DEED CHECK

MAPLE STREET DEDICATION PLAT

APPROVED
LORAIN CO.
MAP. DEPT.
DATE 1-11-89
PAGE 18-00-021 A
BY Carol Franck
VOID AFTER # 18281-A

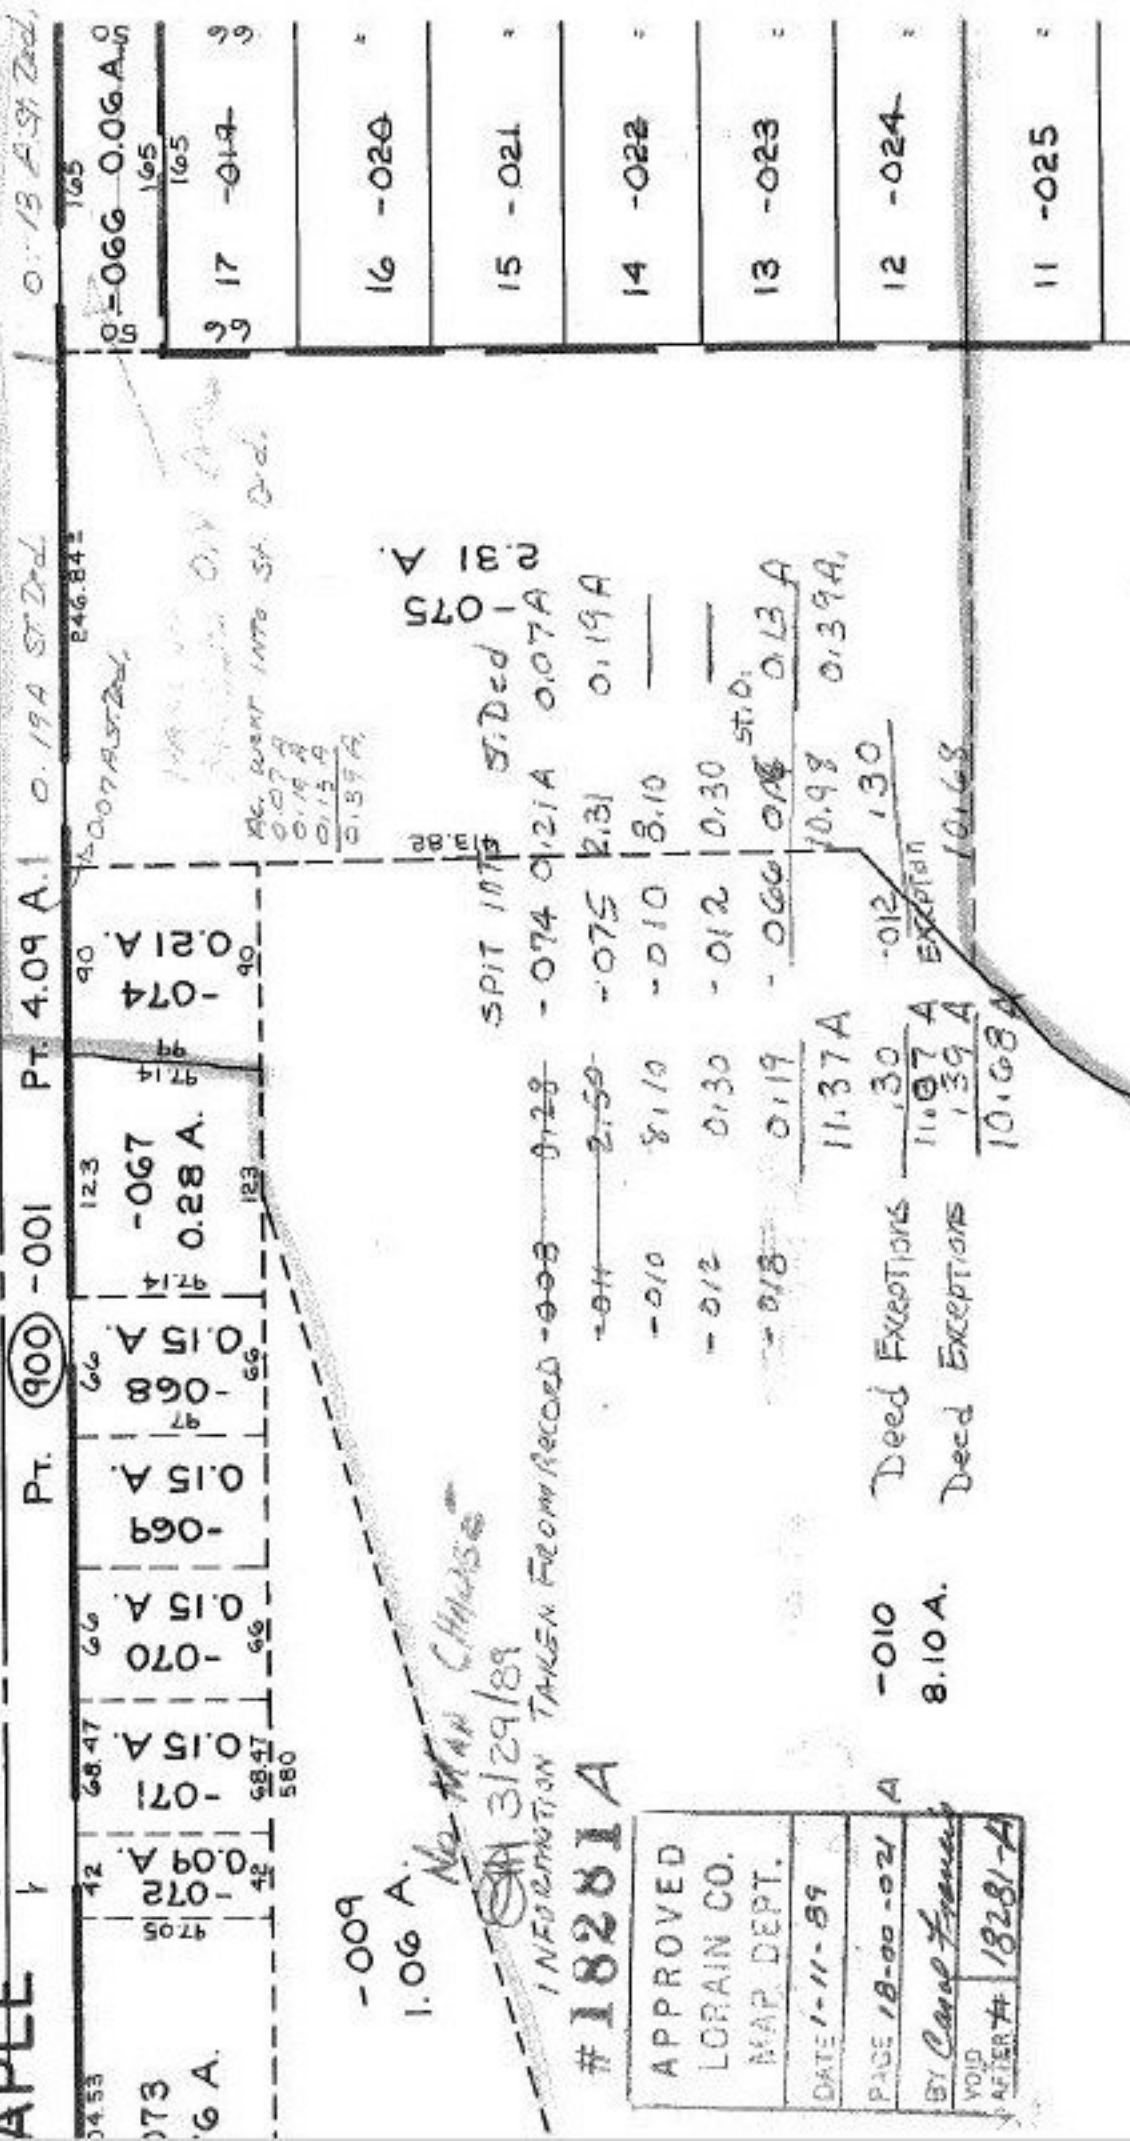
ACREAGES CORRECTION IS NEEDED ON DEED. ALSO THERE IS A TYPING ERROR ON DEED, THE ACREAGE ON DEED READS 10.47 A. INFORMATION TAKEN FROM RECORD IT SHOULD READ 10.49 A. P. P. NO. 18-00-021-101-066 WAS NOT INCLUDED IN THE CALCULATION OF THE ACREAGES ON THE DEED.

18-00-021-101-066 50x165 = 0.19A

10.49A + 0.19A = 10.68A

Deed should Read 10.68 A.
